PLANNING AND ZONING COMMISSION

Monday, June 13, 2016

Subject: Consider making a recommendation on the site plans for DSM Investment Partners located at 4945 NW 57th Avenue (PZ Case 16-16).

RE: DSM Investments Partners Site Plan for 4945 NW 57th Ave
Development Review 2
Case No. PZ 16-16

Dimension Plan @ 4945 NW 57th Ave
 for
DSM Investment Partners, LLC

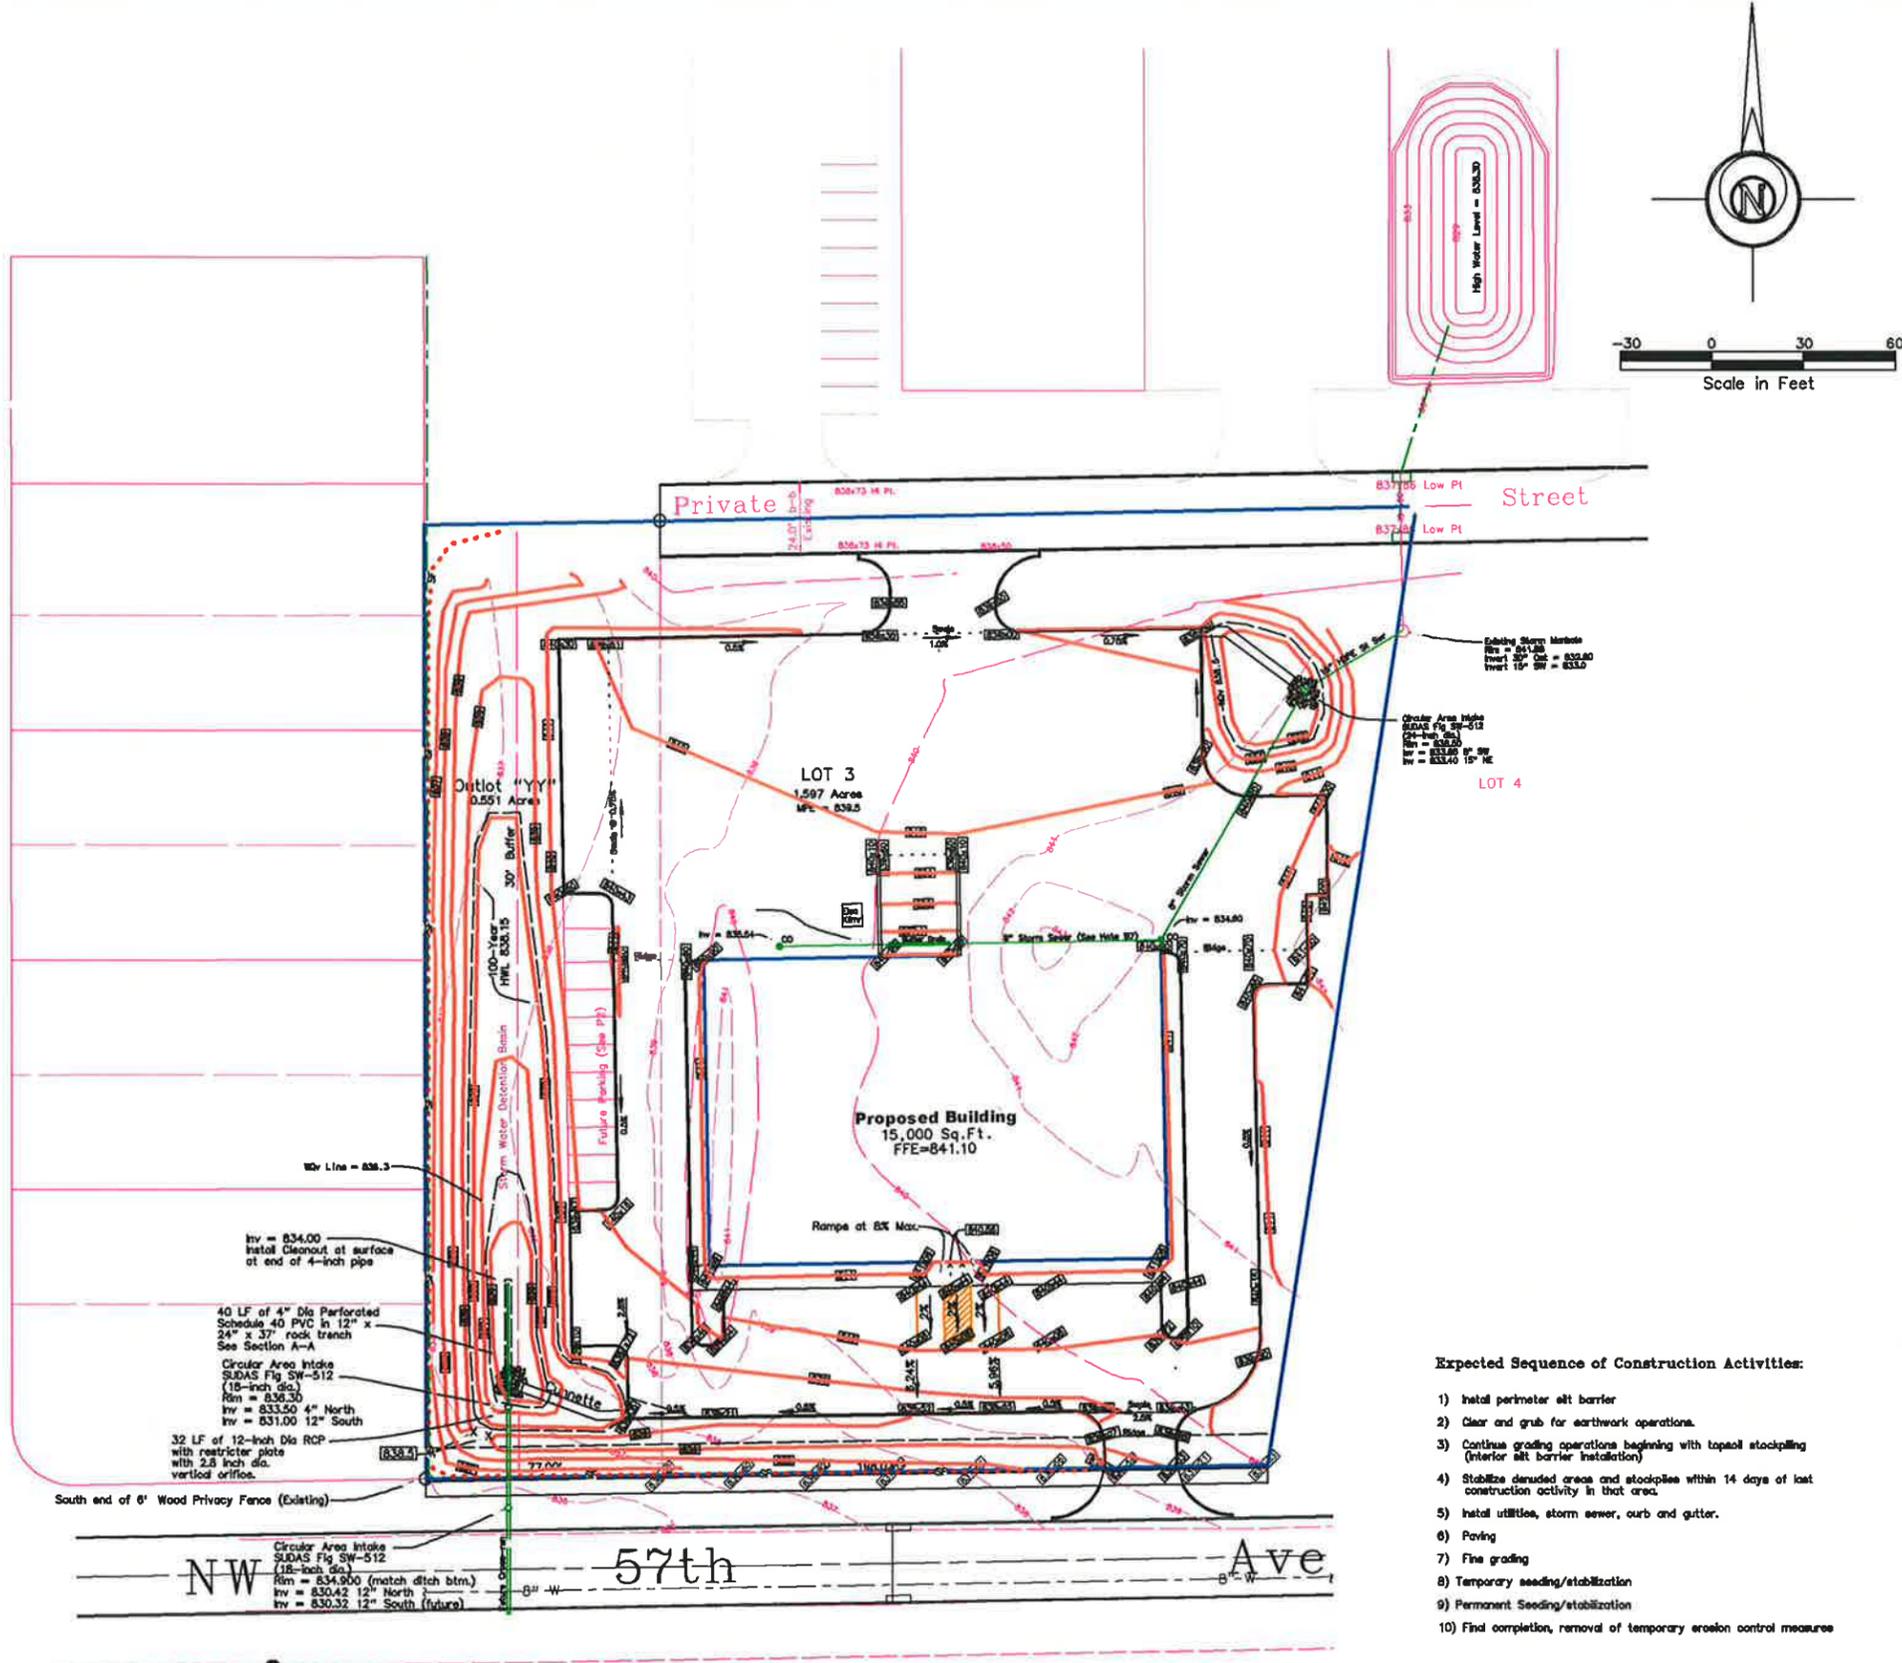
- a. The engineer approval seal section on sheet 1 should indicate that sheets 1, 2, and 3 are covered by the engineers seal.
 - b. Correct the landscaping plan so the buffer and open space landscaping plant schedules match the landscape drawings.

4. A KNOX box will be required for emergency access. Indicate location on site plan.
5. The no parking area next to the handicap spaces needs to be a minimum of 8 feet in width. Please indicate the width of this area to verify ADA compliance.

10. The site plans and architectural elevations appear to show loading docks on the North side of the building. These loading docks must be a minimum of 12 feet in width and 50 feet in length. If these areas are to be ground loading areas they must be at minimum 10 feet in width and 20 feet in length. Indicate the typical size of these loading dock areas.

Dimension Plan

12. Add FL of proposed sanitary service and add critical crossing elevations at water service crossing.
13. Note P4 specifies that 4" curb will be used where indicated, 4" curb is not indicated on plan.

Grading Plan @ 4945 NW 57th Ave
 for
DSM Investment Partners, LLC
 1 inch = 30 Feet
 May, 2016

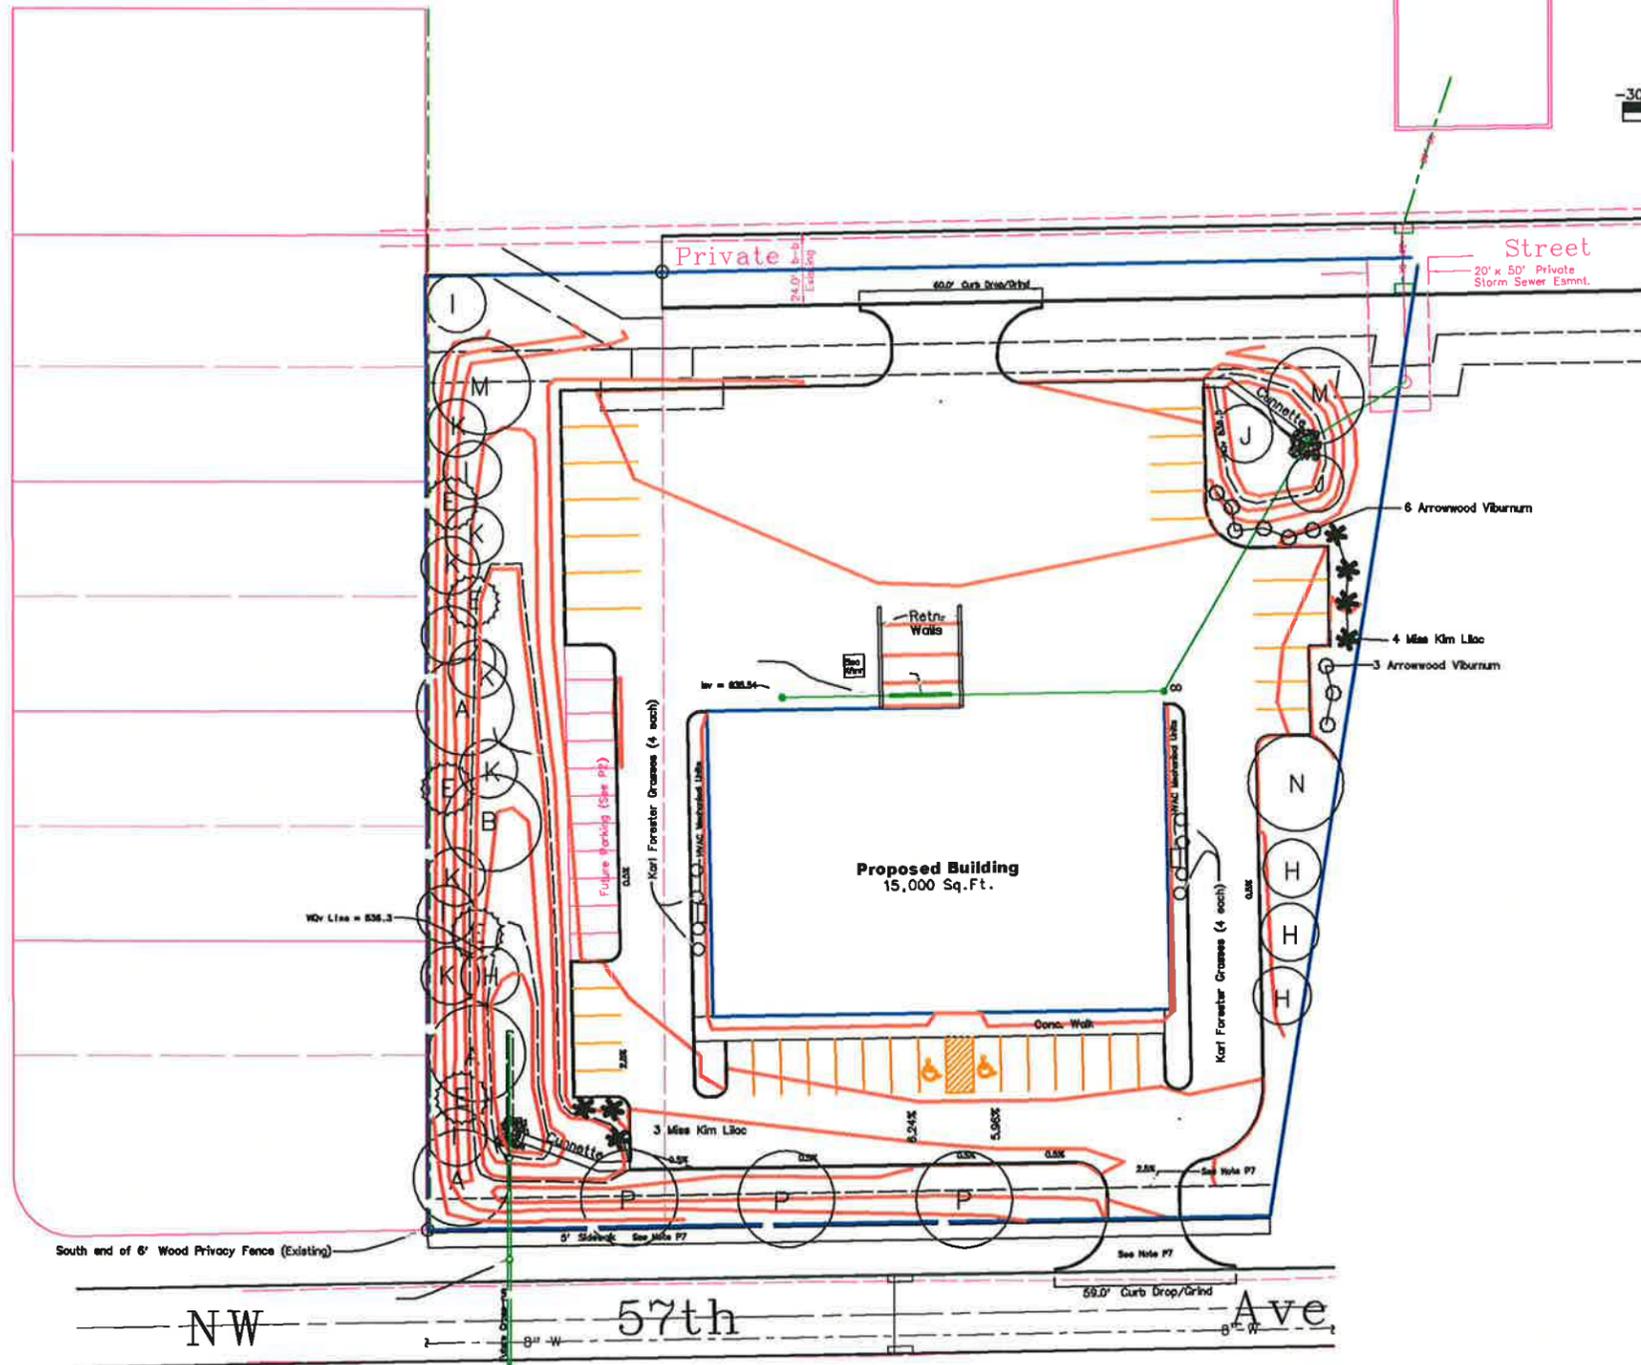
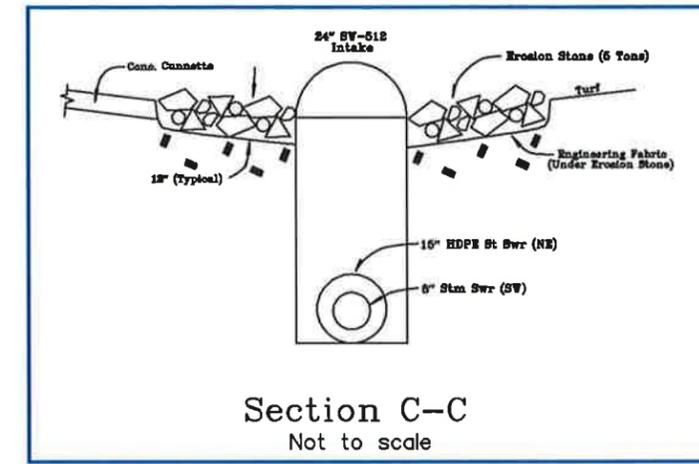
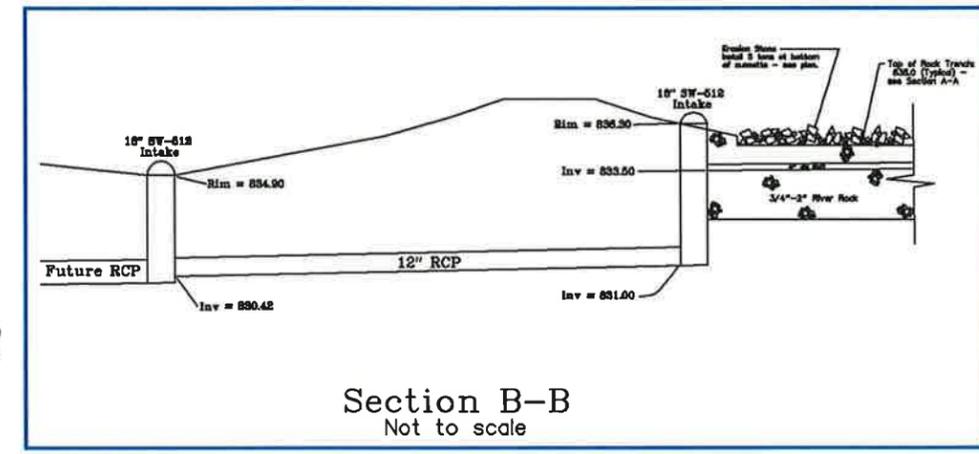
11. Note S1 states that the site is 20.25 acres. Please correct this note.
12. Note S5 is not needed.

Grading Plan

14. Provide top of curb and bottom of curb elevations at front entrance of the building to verify ramp and curb let down meets ADA requirements.

1
A02 South Elevation

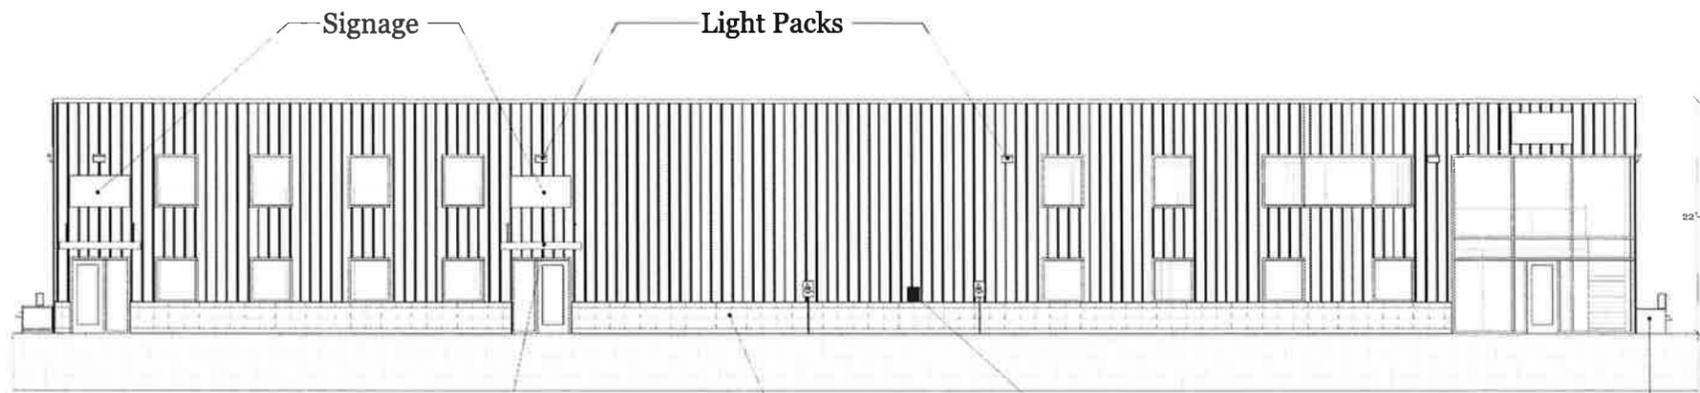
13. All HVAC units must be shown on the site plan and must be screened from view. If located on rooftop, elevation drawings should indicate rooftop systems and screening.
14. The South architectural elevation must consist of at least 25% brick, architectural concrete, textured concrete block, architectural steel, or stone panel. Currently this elevation only consists of 12% brick. The remaining materials do not count towards the 25% requirement.
15. Signage is by a separate permit, but staff would note:
 - a. Total building sign area may not exceed 5% of the total square footage of the south architectural elevation.
 - b. Sign area will be determined using Formula A which can be found in Chapter 170.05, Sign Area Formulas, in the Johnston Code of Ordinances.

Landscape Plan

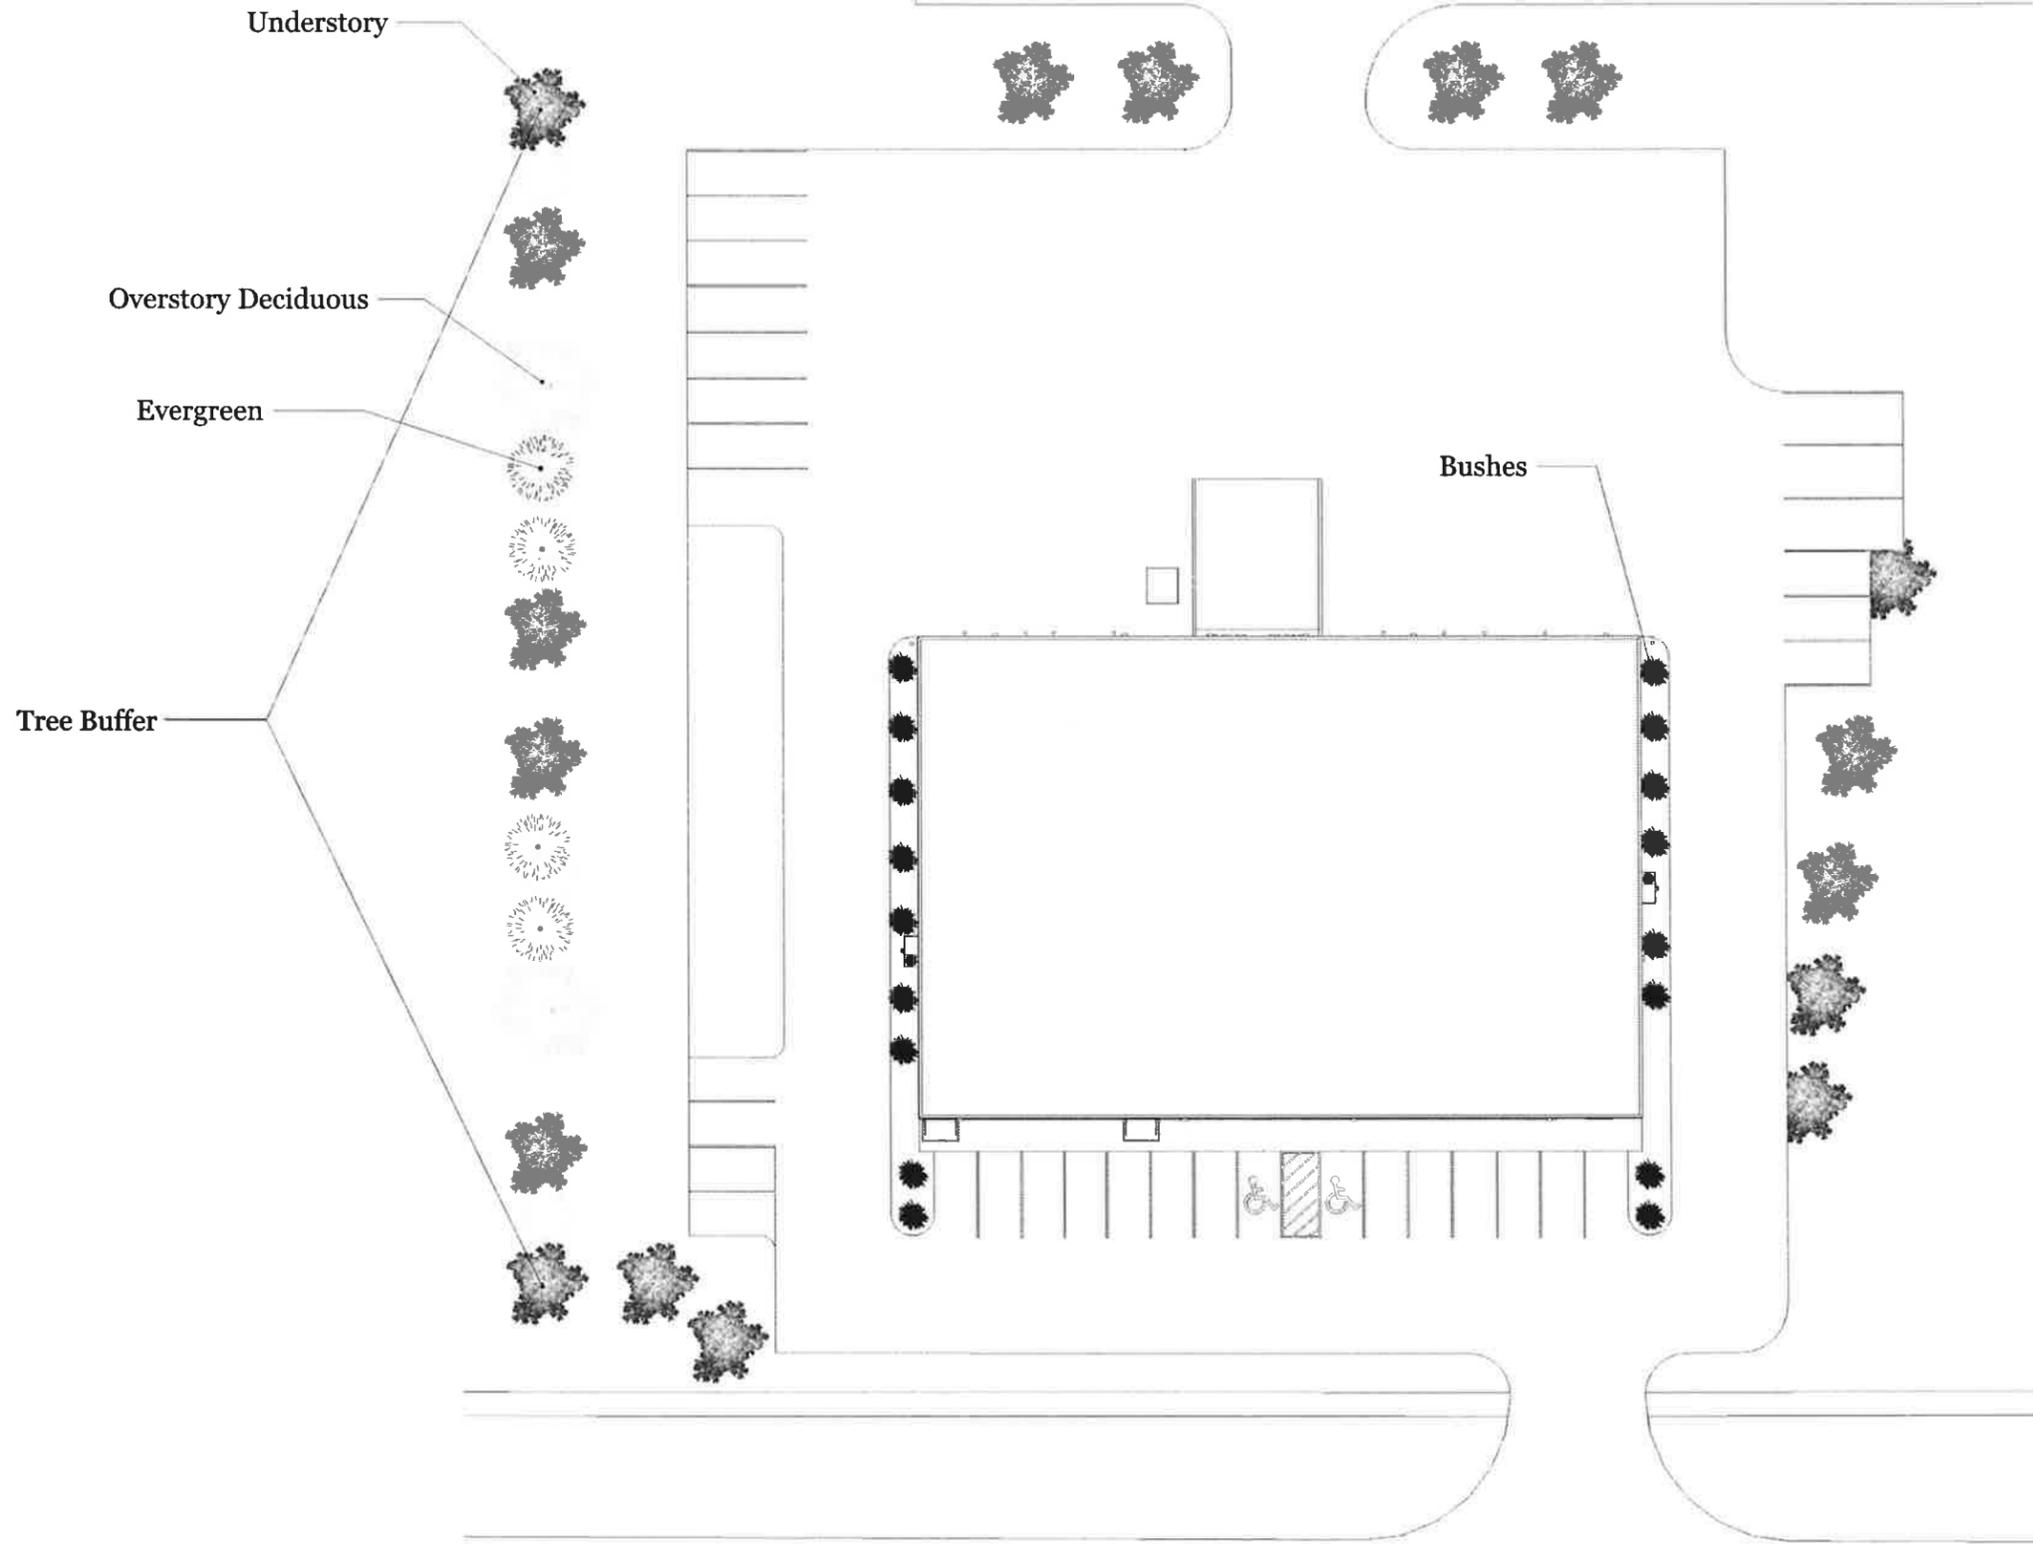
- c. The open space plant schedule shall indicate that 4 of the required open space trees shall be at minimum 2" to 2 ½" caliper diameter. The remaining 7 required open space trees shall be indicated to be at minimum 8 feet in height. Evergreens used to satisfy the minimum open space tree requirements shall not be less than 6 feet in height.

The open space planting schedule lists the sizes of the landscape at the time of planting. Proposed are more open space trees than are required, but the plant schedule and the drawings don't match. This does not impact compliance with city code, but the site plans should be amended to properly reflect what will be planted on the site. As proposed the open space landscaping does not meet the minimum sizes for landscaping at the time of planting though.

According to the buffer landscaping plant schedule there should be one additional species of evergreen tree to meet the evergreen requirement of the buffer. The landscaping drawing does not indicate this tree though. However, since more open space trees are being provided than are required and many are placed within the buffer area one of the evergreens counted towards open space plantings could count towards the buffer plantings. Staff recommends that the plant schedules be amended to reflect the landscape drawings.

Staff recommends a condition of approval that the open space plant schedule indicate that 4 of the required open space trees shall be at minimum 2" to 2 1/2" caliper diameter. The remaining 7 required open space trees shall be at minimum 8 feet in height. Evergreens used to satisfy minimum the open space tree requirements shall not be less than 6 feet in height.
